**Coal Combustion Residue Impoundment**

**Round 12 - Dam Assessment Report**

*Martin Lake Steam Electric Plant*

*Luminant*

**Figure 10 - Leak in Flexible Hose**

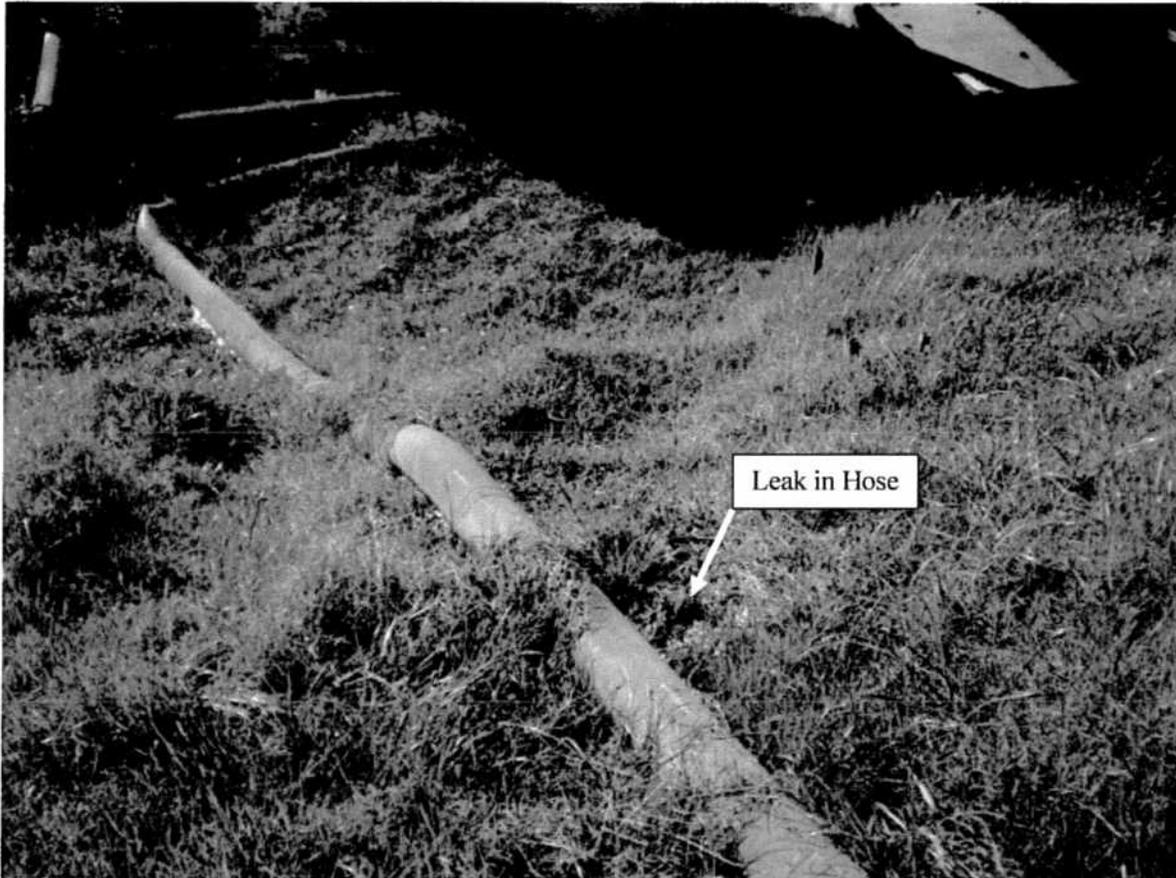
MODERATE ITEM: Along the south side of the impoundment, near the Low Volume Pump Station, a flexible hose was transporting water from the catch basin to the Emergency Sludge Pond. This hose had a leak that was allowing water to jet out and erode the outer face of the berm (Figure 10).

Luminant initiated corrective action to repair the hose while the inspections were occurring.

**Figure 11: Leak at 3C ESP Pump**

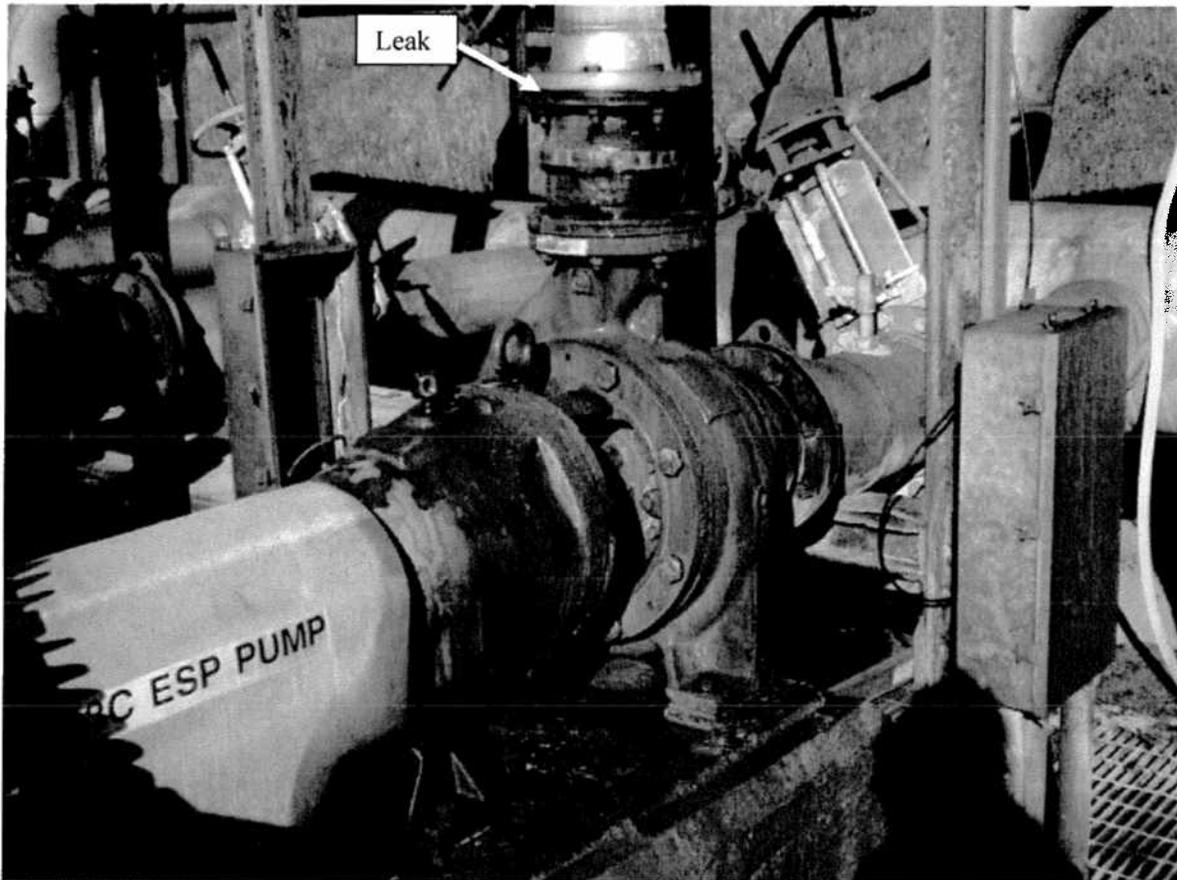
MODERATE ITEM: At the Low Volume Service Pump area, a leak was observed in the "3C ESP Pump" from the coupling (Figure 11).

Recommendation 2: Luminant intends to construct improvements to manage uncontrolled releases of water from this location in 2013.

**Figure 62: Tear in Liner and Outfall Exceeds Sacrificial Liner**

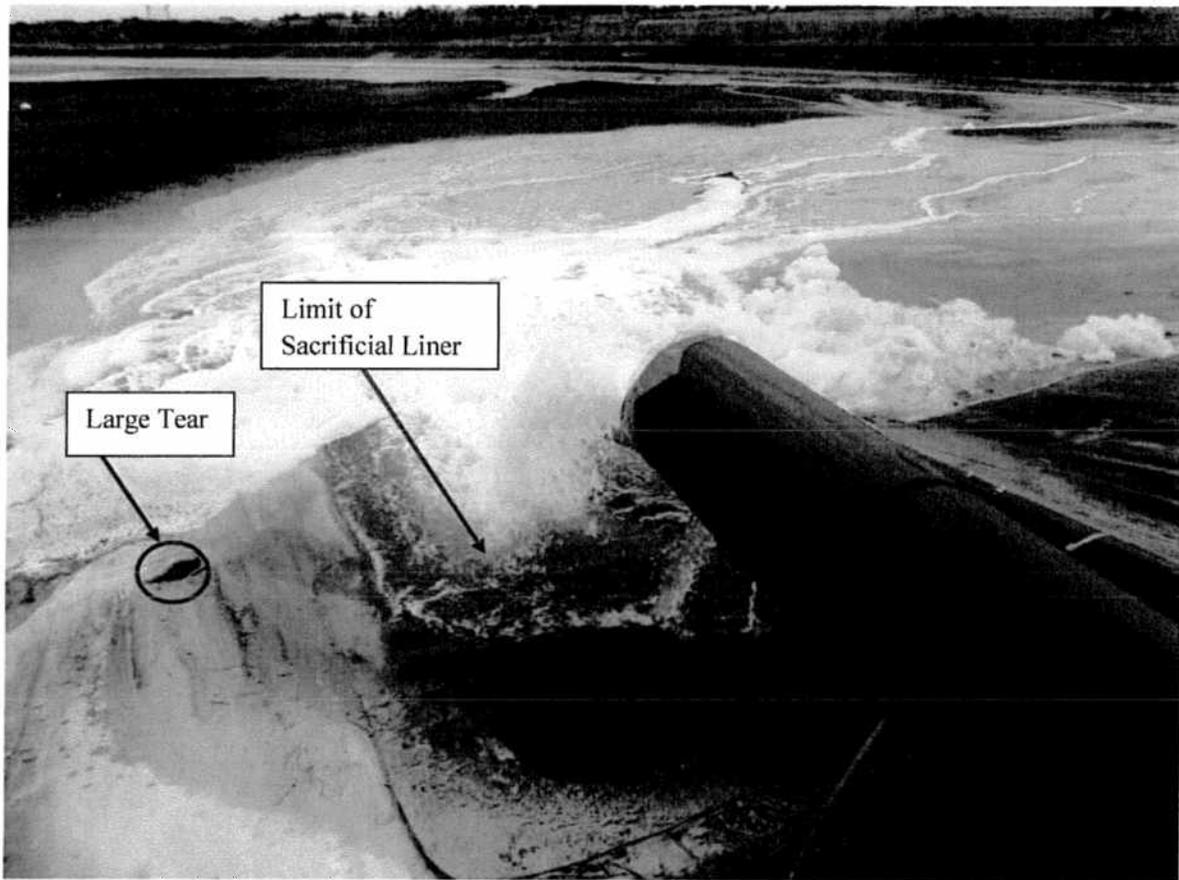
**CRITICAL ITEM:** The most significant action item discovered at this pond was a large tear in the liner (Figure 62).

**MODERATE ITEM:** A sacrificial liner was installed near the outfall of the pipes from PDP #5 near this tear. As shown in Figure 62, the outfall is exceeding the limits of the sacrificial liner.

**Recommendation 1:** Install another sacrificial liner beyond the limits of the pipe discharge.
